UNITED STATES  
NUCLEAR REGULATORY COMMISSION

SUBJECT: VIOLATION OF LICENSE CONDITION; FAILURE TO COMPLETE  
INVENTORY OF NRC LICENSED MATERIALS

SUBJECT: STATEMENT OF WORK FOR THE SAFETY ASSESSMENT OF THE ADVANCED  
MEDICAL SYSTEM'S FACILITY (LICENSE NO. 34-19089-01)

Project Title: Advanced Medical Systems, Inc., Facility Hazard/Risk Assessment

FIGURE 5-2: Stack Air Sampling System: Schematic Diagram

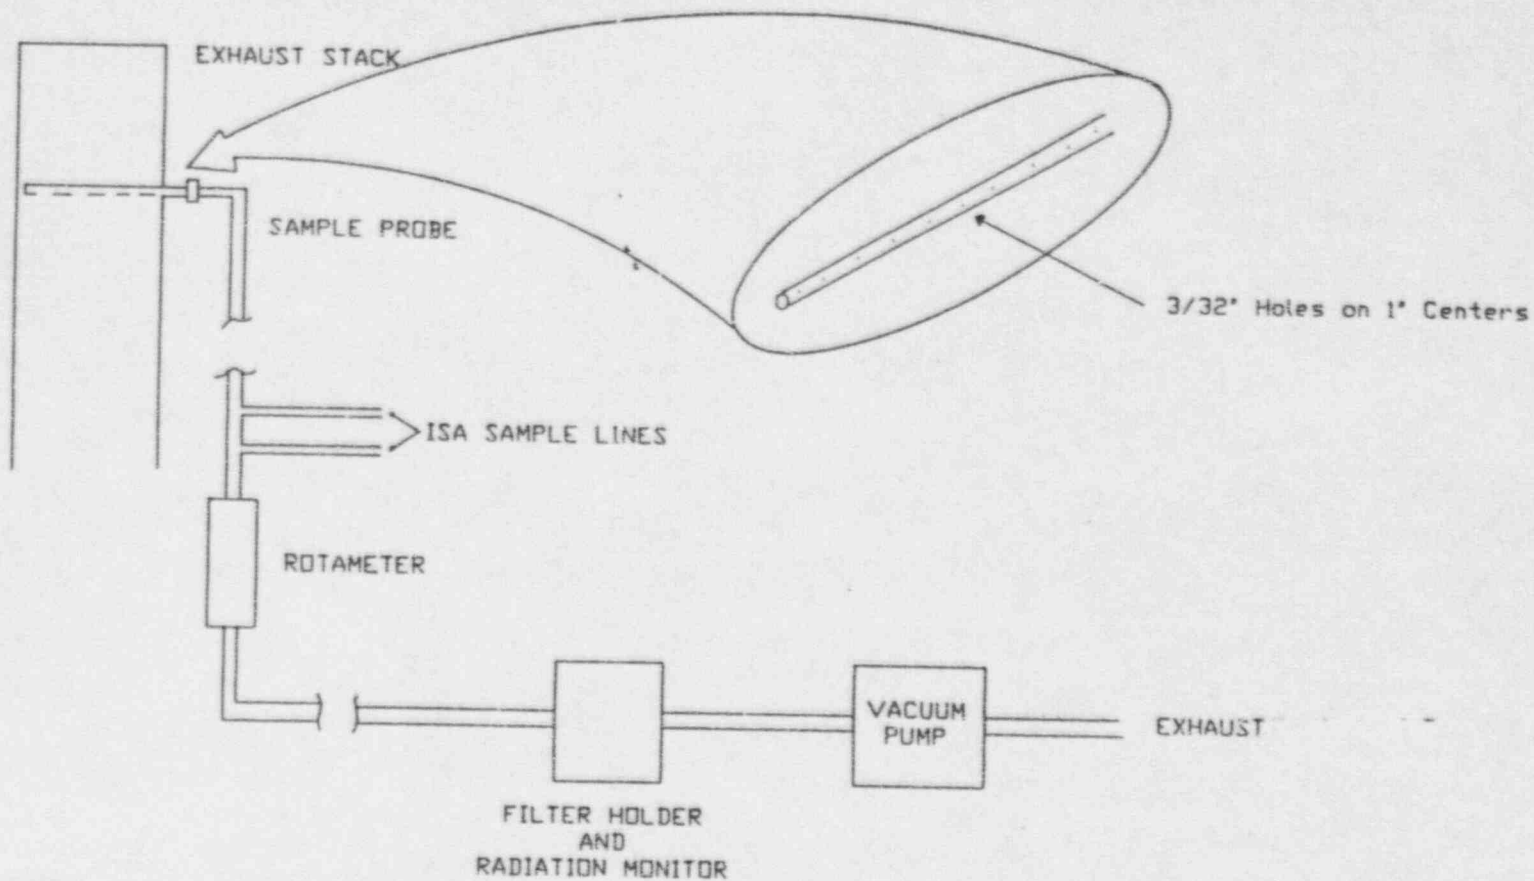
- ° The stack sampling system (Figure 5-2) is composed of a stack probe, sample line, flow meter, filter system and pump.
- ° The existing drawings indicate at least 70' of sample line from the probe on the roof to the filter paper in the basement. The sample

- ° The stack probe design is not compatible with ANSI stack sampling recommendations, and the air is not isokinetically sampled from the stack.
- ° The prescribed stack sample flow rate was 5 cfm and the indicated flow rate was 6 cfm at the time of the audit; however, this includes the flow rate from the two ISA fixed stations.
- ° The stack is sampled continuously, with a monthly filter change. The filter loading has been assumed to be negligible.
- ° Air samples were collected from the stack, hot cell, decon room and ISA; the results are reported in Section 11.0, Site Survey.

5. Change the filter paper sample media to 0.8  $\mu$ m millipore paper.  
Monitor the filter loading by change in rotameter flow.
6. Record beginning and ending flow rate to document filter loading  
and change out frequency.

FIGURE 11-10: Facility Radiation Leakage Locations  
(For additional description of this figure, see Section 11-0, Site Survey.)

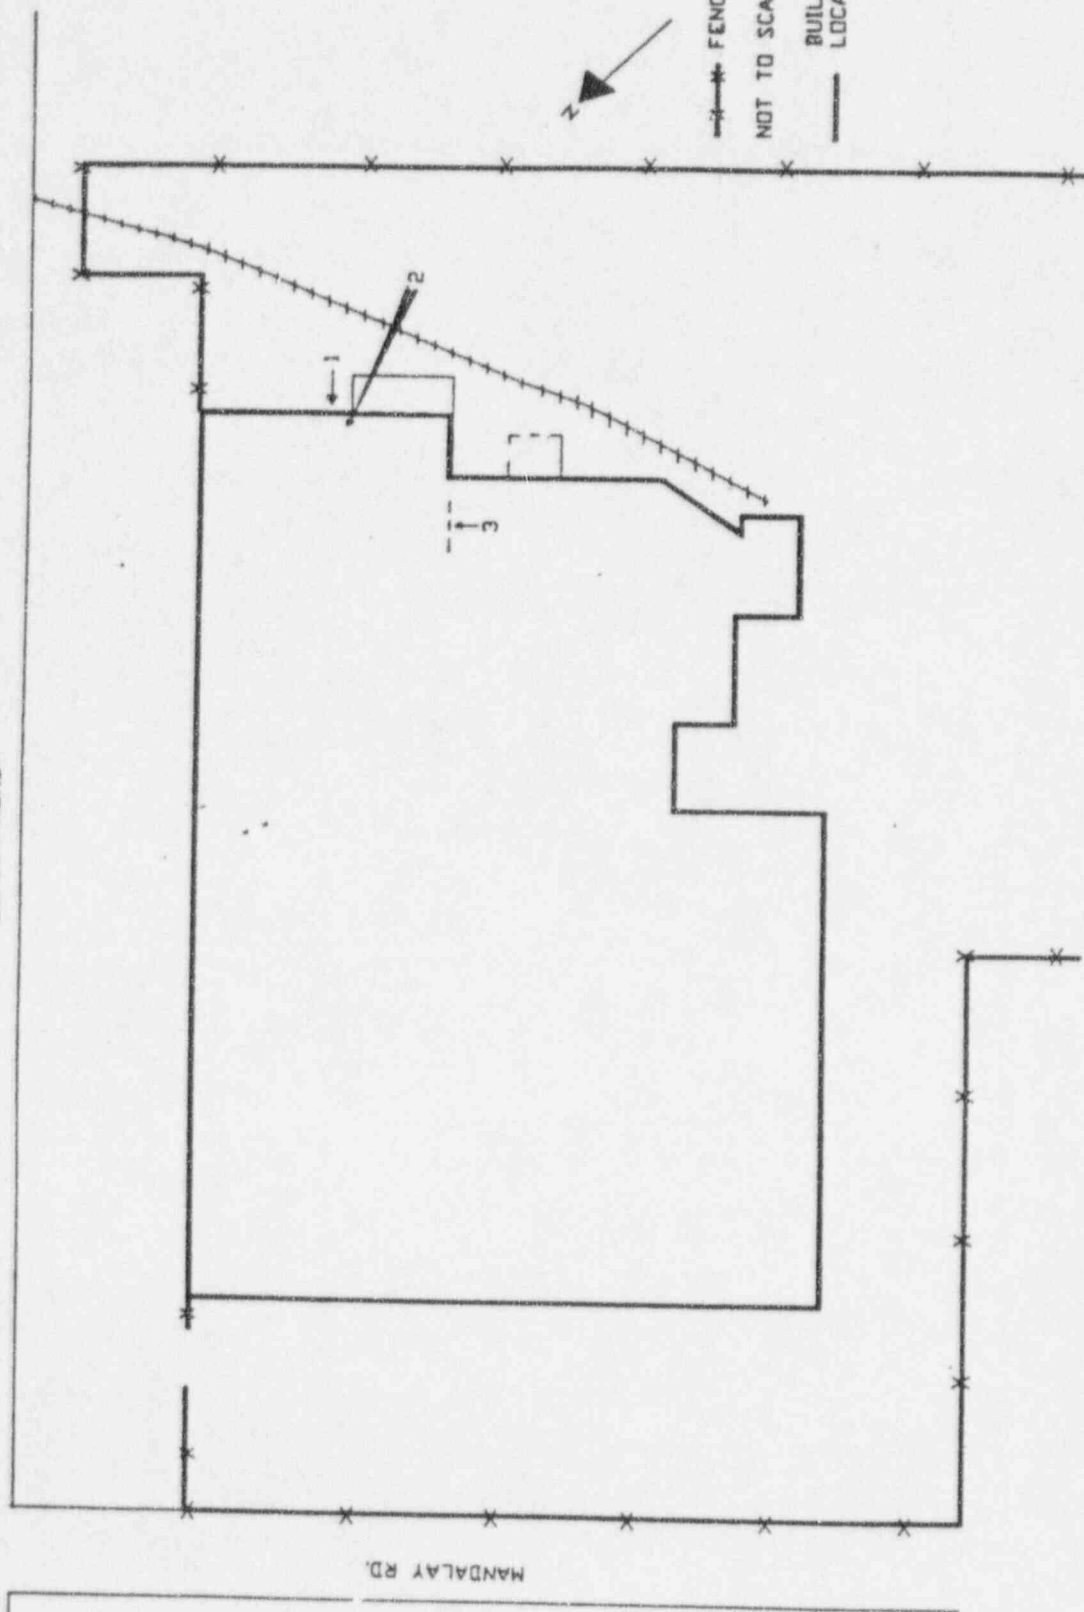
Figure 11-10 depicts three locations where radiation leakage occurs from the building. Area 1 measured 0.6 mR/h and is located opposite the access ports from the hot cell. Area 2 occurs in a narrowly defined beam approximately six feet off the ground, and measured 0.5 mR/h at the fence line. This beam originates from the cell exhaust HEPA filter room on the second floor. Area 3 occurs in a wide flat beam streaming along the top edge of the Hot Cell door. This beam is only detectable on the roof and measured 6 mR/h at the location indicated.

Quarterly exposure-rate measurements on the roof and inside the fence should be performed. These measurements may indicate areas where additional shielding can reduce external exposure rates. (i.e. The Area 2 exposure rate could be reduced by adding a solid concrete block wall on

the southwest corner of the facility where the second floor access door is located. Also, action to improve the pre-filter media, and reduce the contamination on the HEPA filters, will reduce the direct radiation levels.)
